Linden Avenue Assisted Living Facility | 2nd Early Design Guidance
13524 Linden Avenue N
DPD Project #3020289

Design Review Board Recommendations & Response

OPTION #2-REVISED

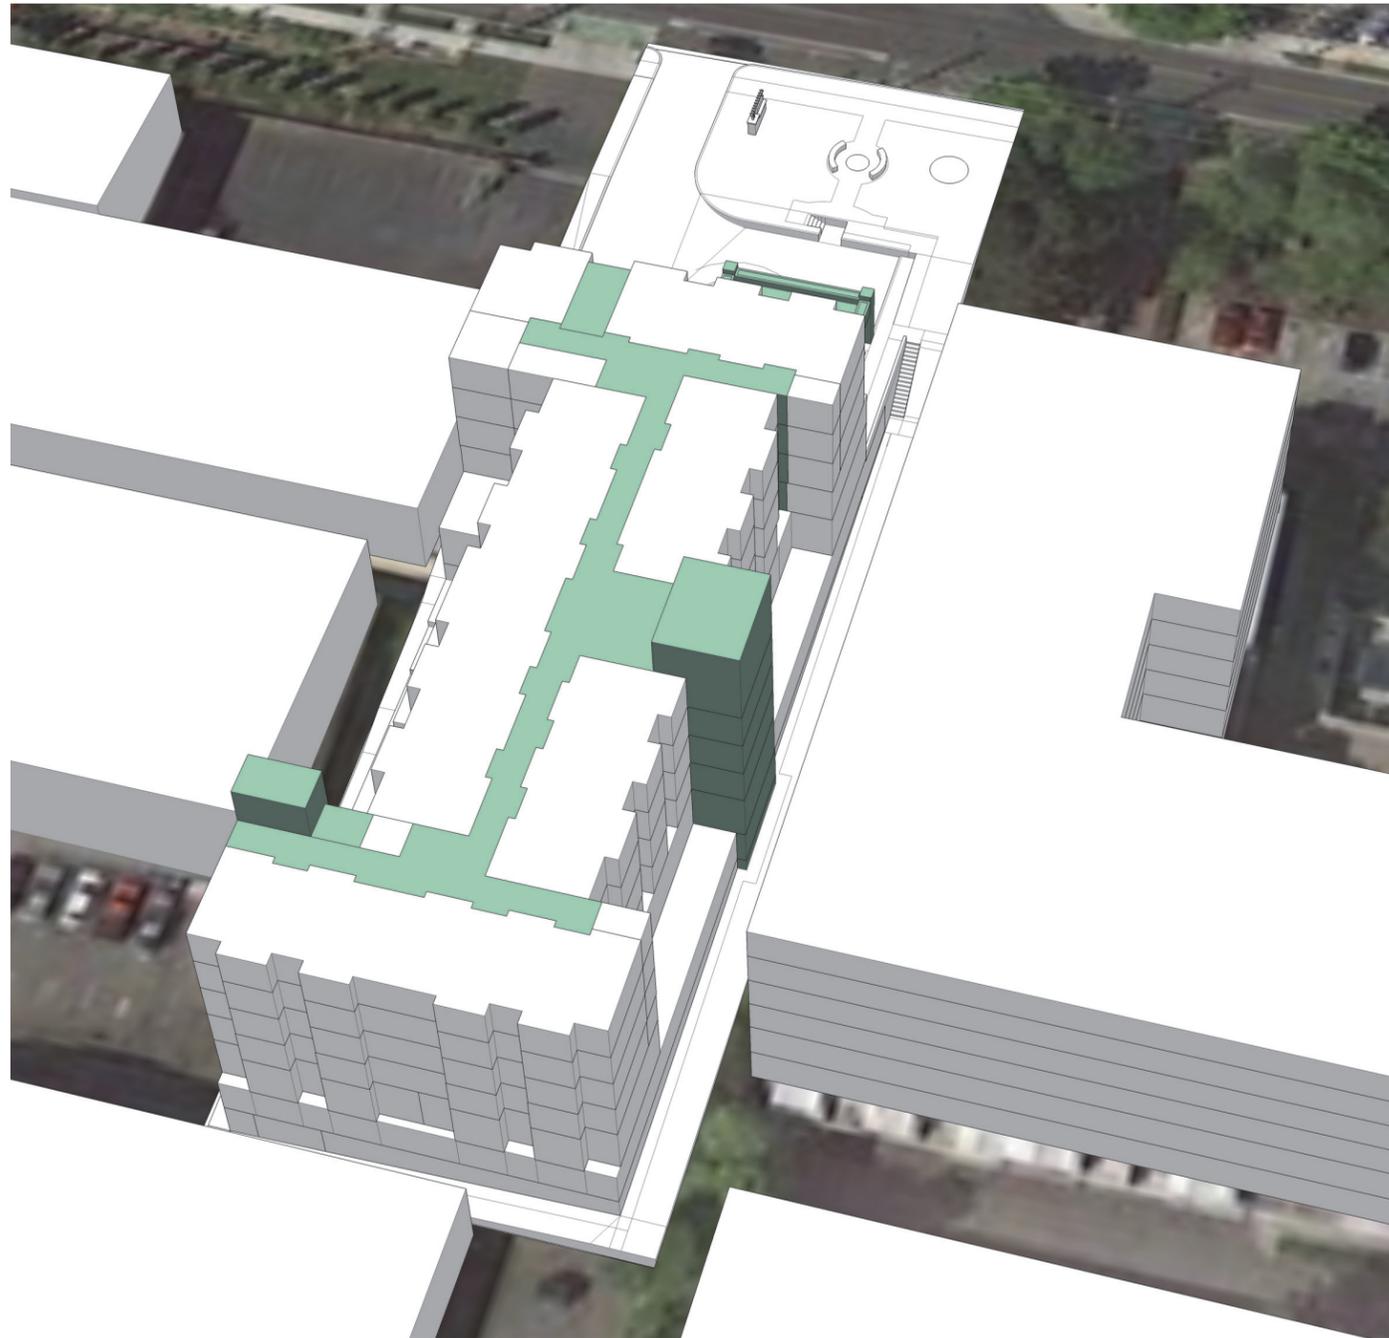
1a. At the first EDG meeting, the Board expressed general support for Option Two because the north and south upper-level setbacks provided more light and air and better addressed potential privacy conflicts with adjacent uses. For the next meeting, the applicant should modify the massing to maximize light and air to the greatest number of units, including to the adjacent properties. **(CS1-B-1, CS1-B-2, DC2-A-1)**

- Option #2 is selected and revised based on the Board’s design guidance.
- Placement of the center of the framed portion of the building is nearly equidistant from the north and south property lines.
- The extent of light and air between the proposed senior care units and adjacent buildings are maximized.

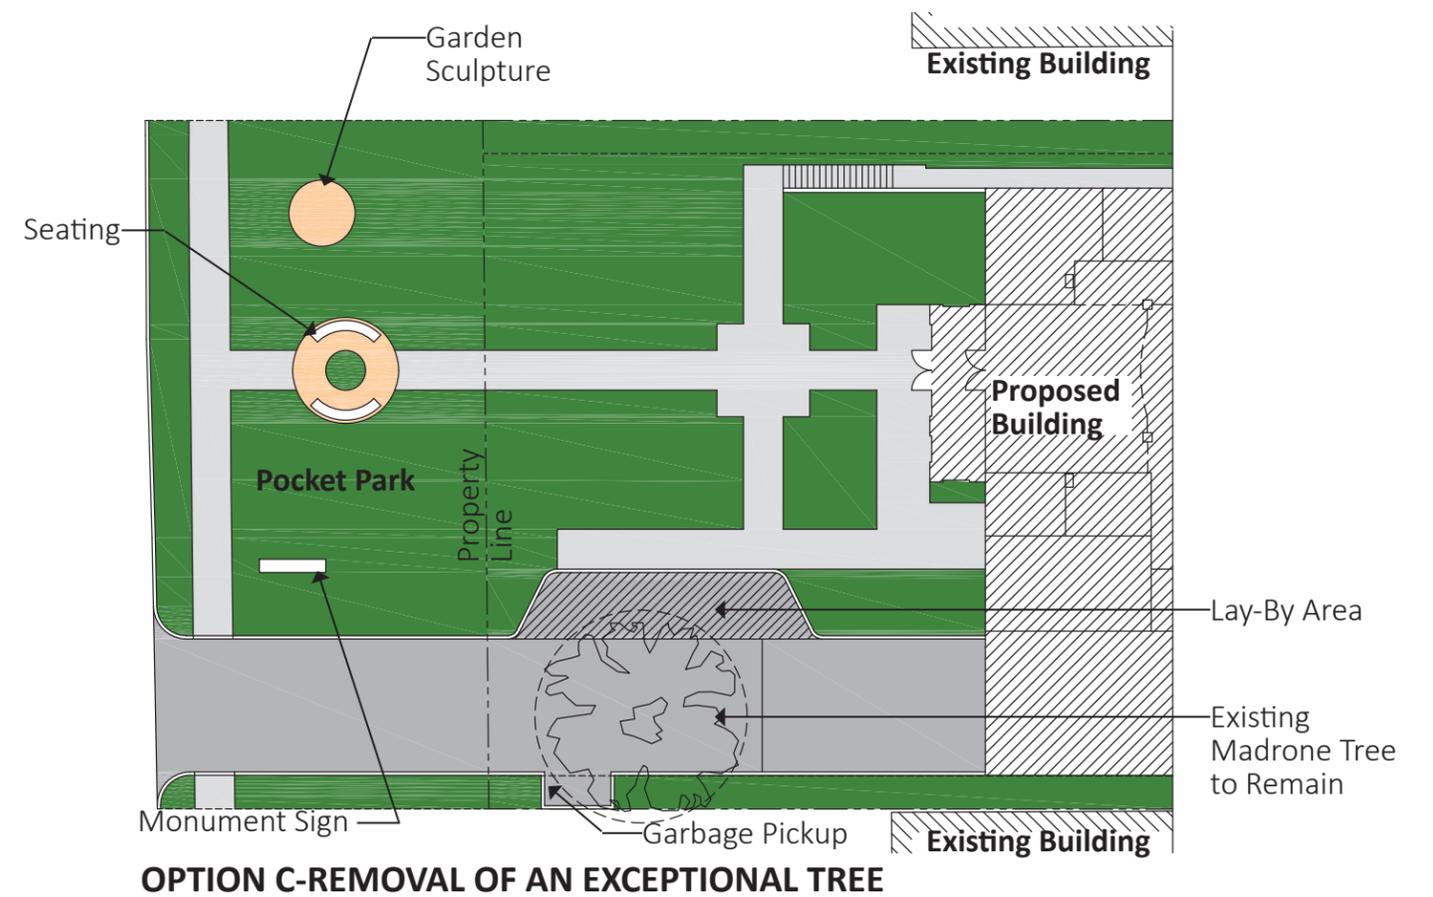
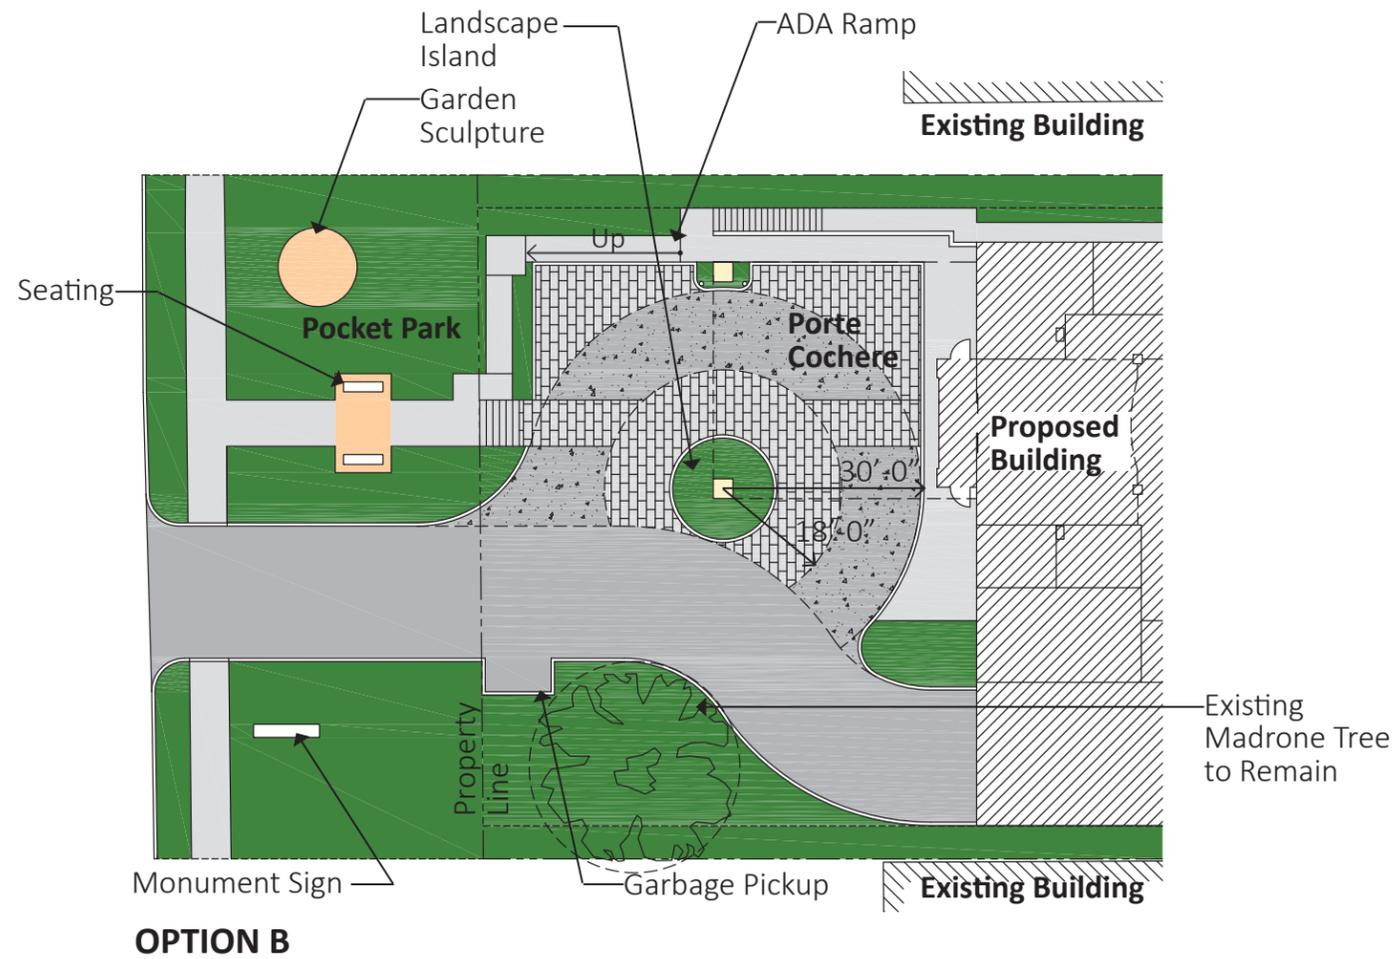
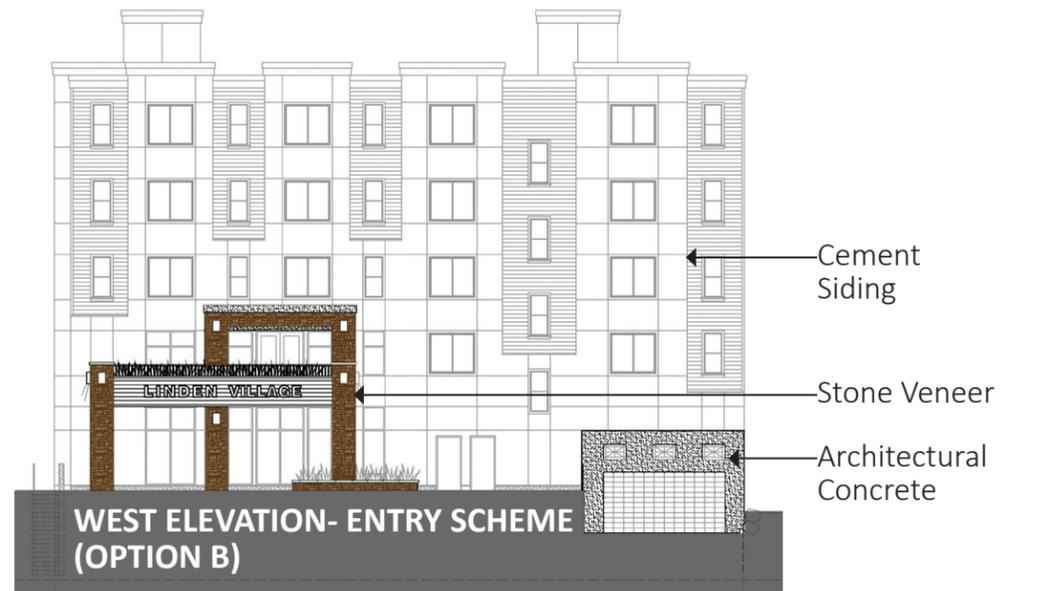
The Board discussed the siting of the massing and access and the removal of the Exceptional Tree (30" Pacific Madrone) on-site. At EDG, the Board was open to the possibility of removing the tree but stated that the onus was on the applicant to provide a compelling reason for removal of the tree that would result in a better building design and would better meet the Design Guidelines. (DC2-A-1)

- The Madrone tree is in a fair condition, but is susceptible to diseases per the arborist's report.
- The Bitter Lake UDF Direction has recommended a long-term option of replacing the Madrone tree with a new Fir tree (or evergreen tree), which is more characteristic of the area.
- Option A proposes to plant 2 new evergreen trees in the R.O.W. and 15 other trees onsite (see Landscape Plan).
- Option B proposes to keep the Madrone tree. This approach will have a negative impact to the "pocket park" design, by dividing the R.O.W. into two smaller unusable green areas.
- Option C provides a lay-by alternative. This option is impractical because it does not allow vehicle turnaround.

Aerial View at East Edge

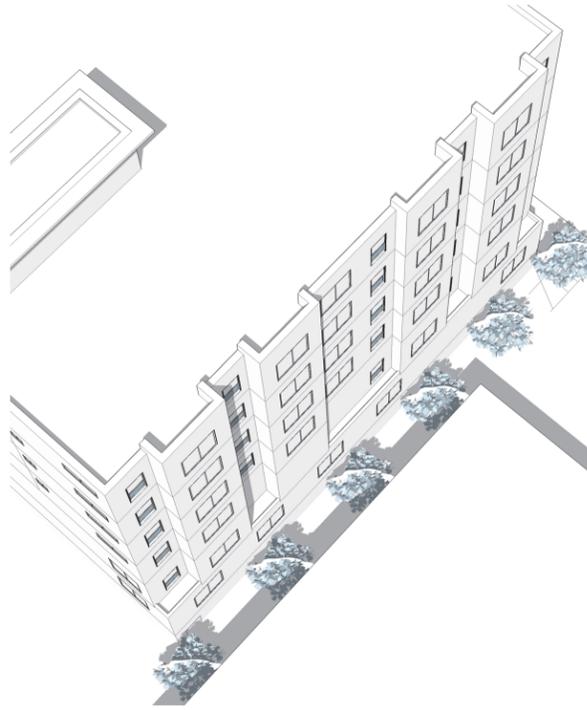
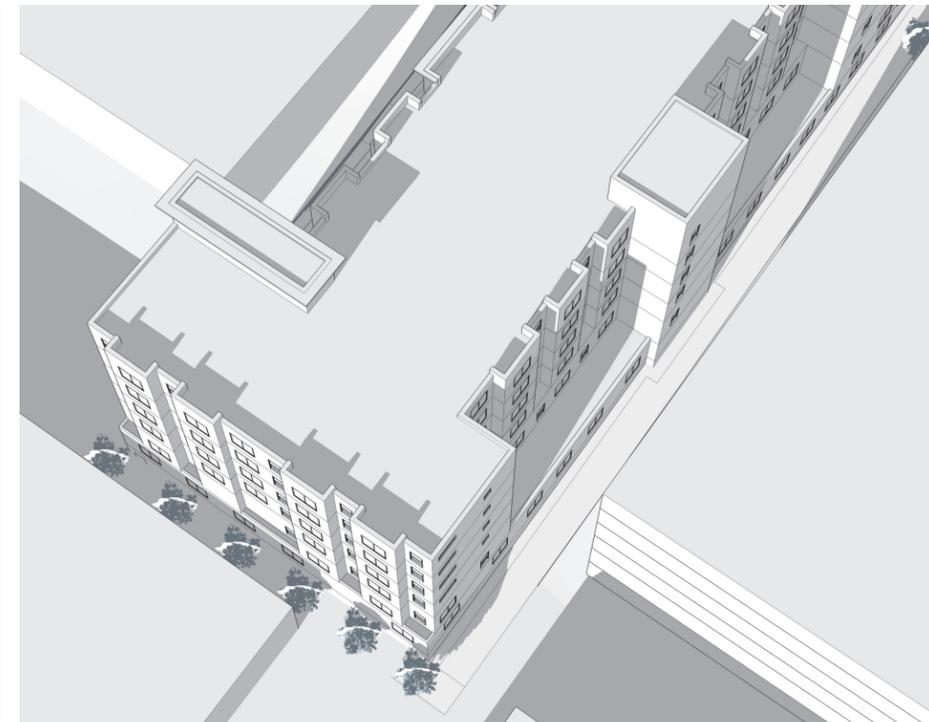
The Board expressed concern with the flat facades and lack of modulation on the north and east facades. The Board directed the applicant to incorporate additional modulation and interest along all facades. (DC2-A-1, CS1-B-2)

- The building modulation is further extended down to the concrete deck level (2nd Floor). A line of trees that can grow up to 12' to 15' tall are proposed on the east edge to help soften the hard wall surfaces. The east facade is further moderated by exterior unit windows on 1st Floor.

- The building modulation is greatly improved by shifting the middle framed portion of the massing away from the north property line, thus creating more interests to the facade treatment.

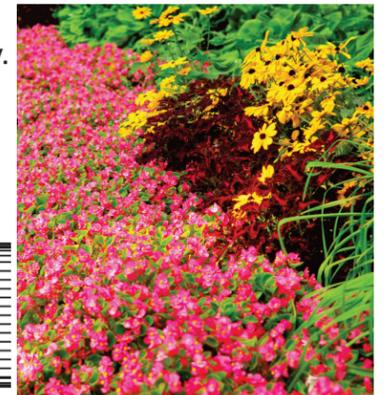
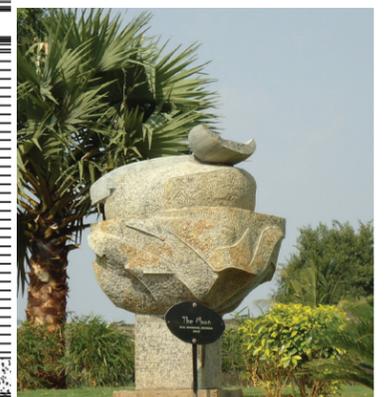
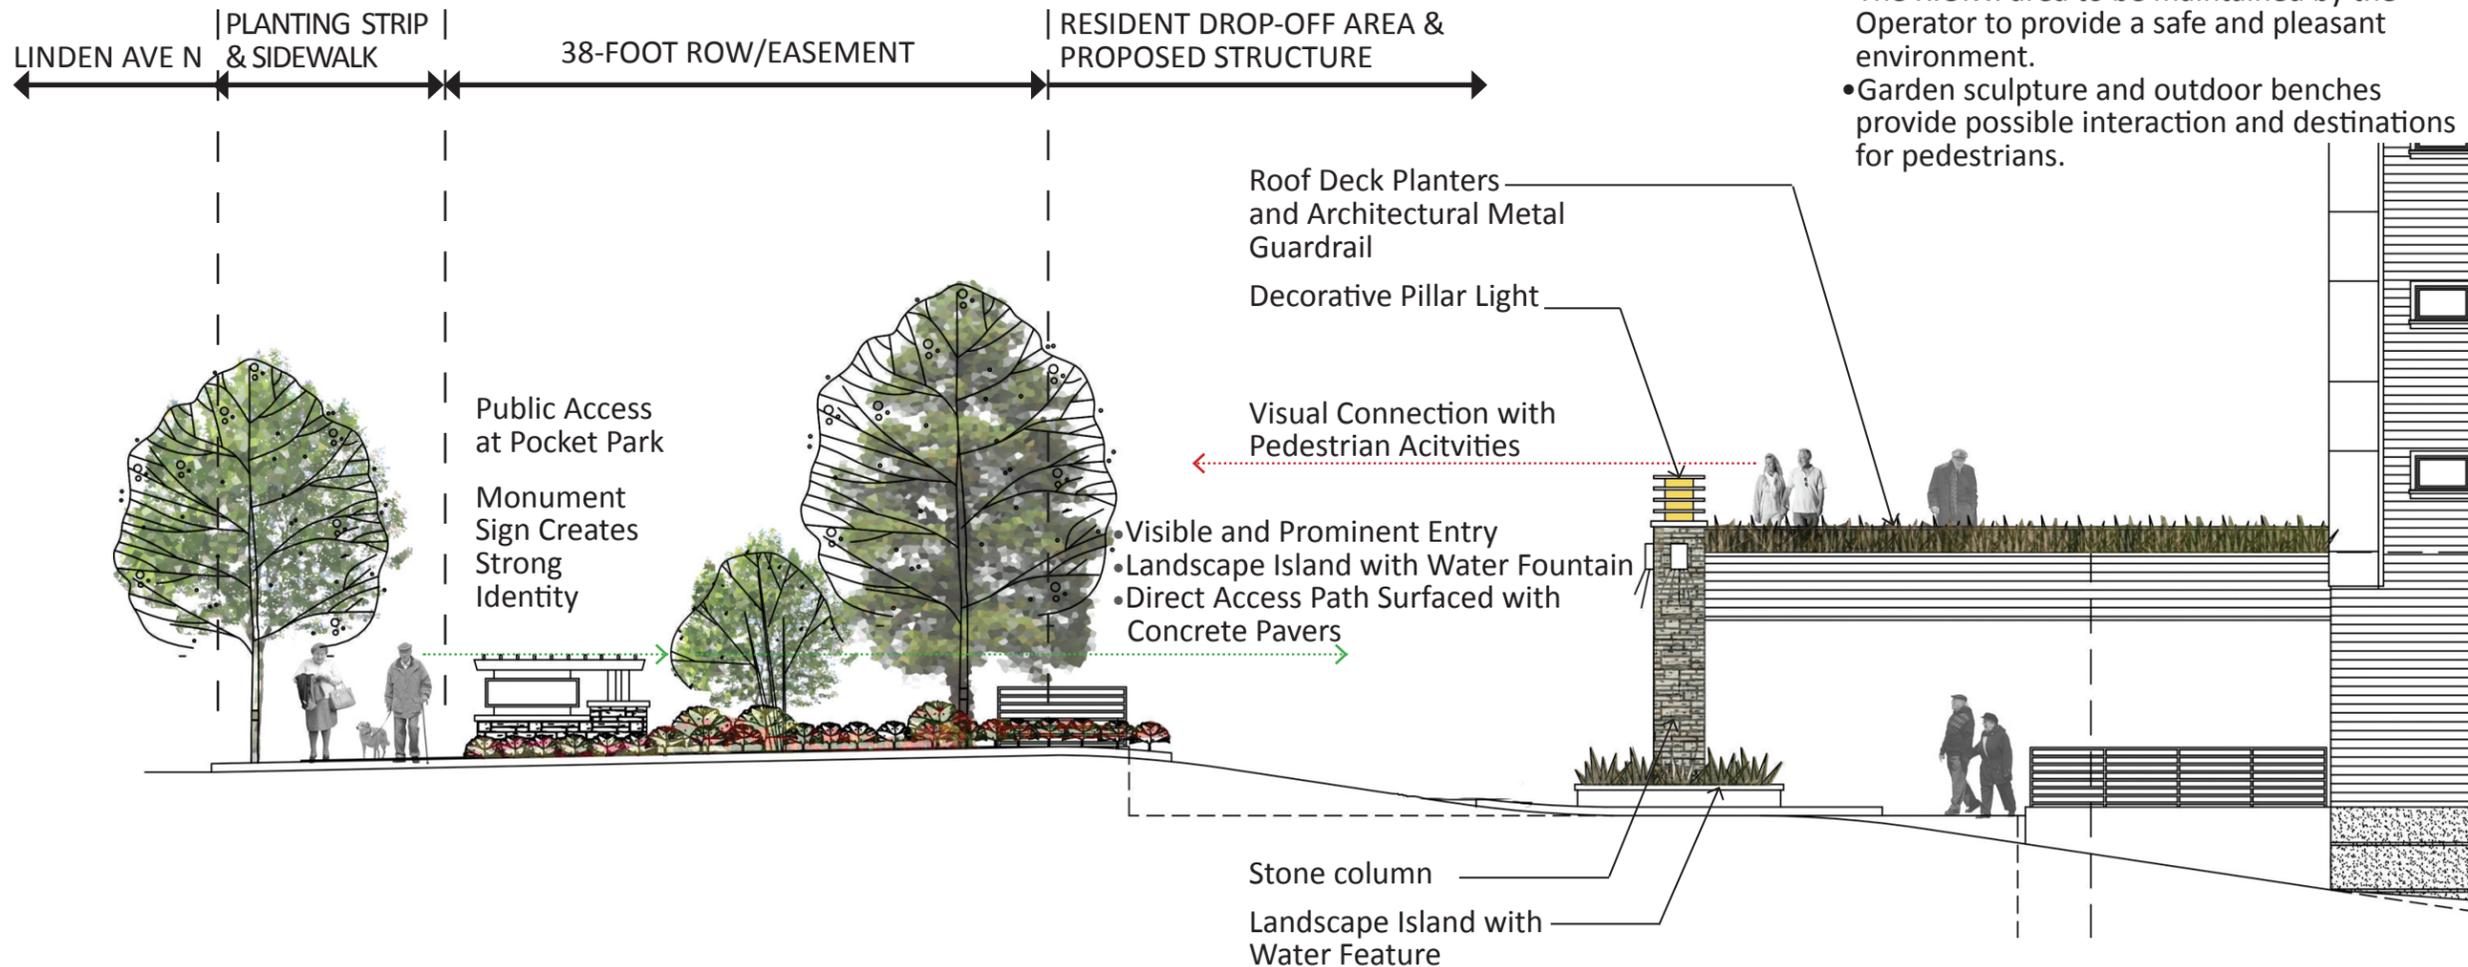
The Board noted that the primary entry to the site should be easily identifiable and significant. The primary entry should be integrated into the larger architectural concept and secondary architectural features and materials should be used to further emphasize the entry. (PL3-A-1, PL3-A-2, PL3-A-4)

- The previously proposed surface parking has been replaced by a traffic circle type of resident drop-off area.
- The resident drop-off area is functionally logical and programatically essential for this type of use (Assisted Living Facility).
- Visible and prominent primary entry is established with the presence of the Porte Cochere structure and roof deck, reinforced by secondary architectural features such as landscape island, water fountain, concrete pavers access path, stone columns, roof deck planting and site lighting.
